**TASMANIA DEPARTMENT OF MINES
UNPUBLISHED REPORT 1977/56**

**Inspection of a proposed subdivision
at Craythorne Road, Rosevears**

Figure 1

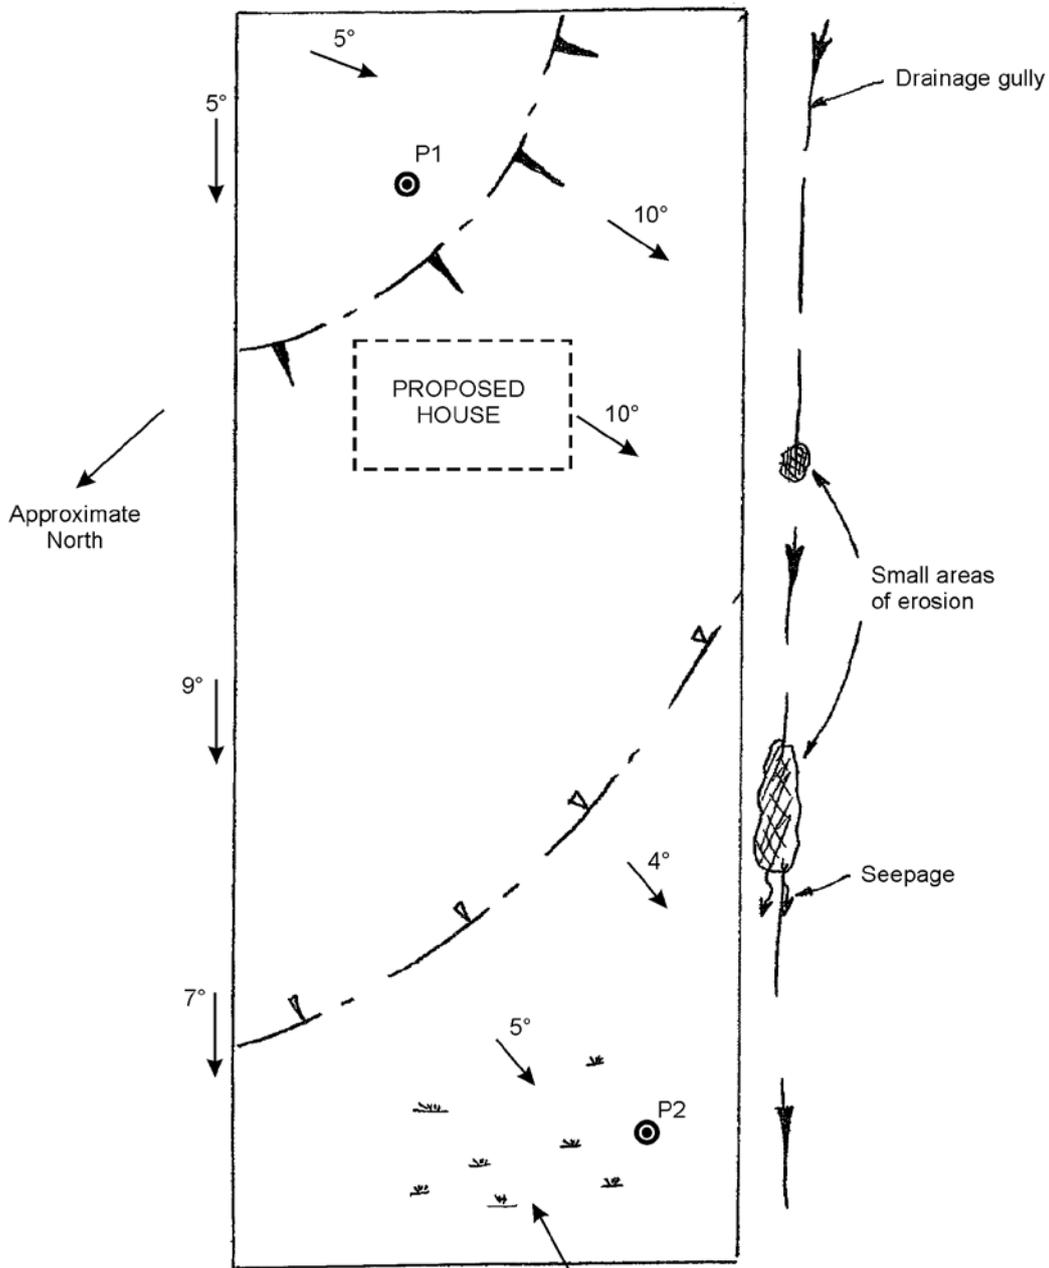
The slope and drainage conditions present on the proposed site are shown on Figure 1. There is evidence of seepage from a small gully along the south-western boundary of the block and the western corner of the block becomes very swampy during winter. The Beaconsfield Council apparently will not allow a septic tank system to be installed in this area.

These pits show that clay is present at shallow depth and exhibits low to moderate plasticity between depths of 2.9 and 3.0 metres. In view of this, together with the fact that the septic tank system will have to be located on the 10° slope segment, it appears unwise to approve this subdivision. The surrounding area in general has morphological features indicative of old landslips and is similar to the Bradys Lookout region where landslips are currently active. Inspection of the remainder of the property could be conducted upon request, with the view of selecting a more suitable building block. Such an area would be required to have a region of shallow slope (less than 7°) large enough to accommodate the house and septic tank sewerage system. The area just to the south-west of the present proposal may be suitable.

Figure 2

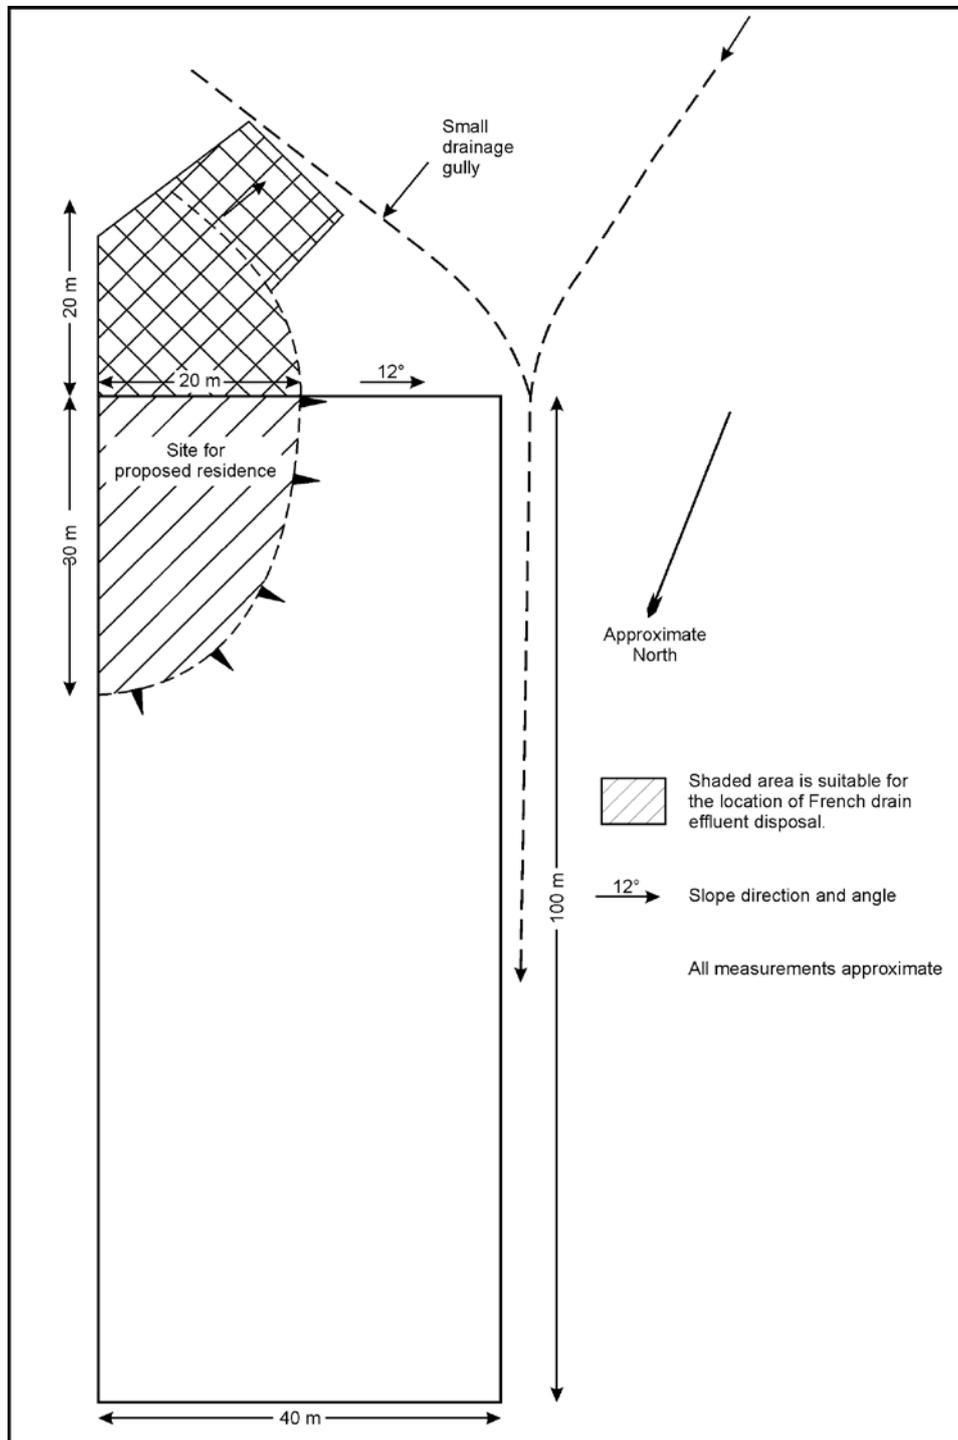
The area was re-examined in March. It is advised that the proposed residence be located in the area shown on Figure 2. A suitable area for the location of a French drain system for sewage effluent disposal is also shown on the sketch map. A drainage easement will be required if this area is to be used.
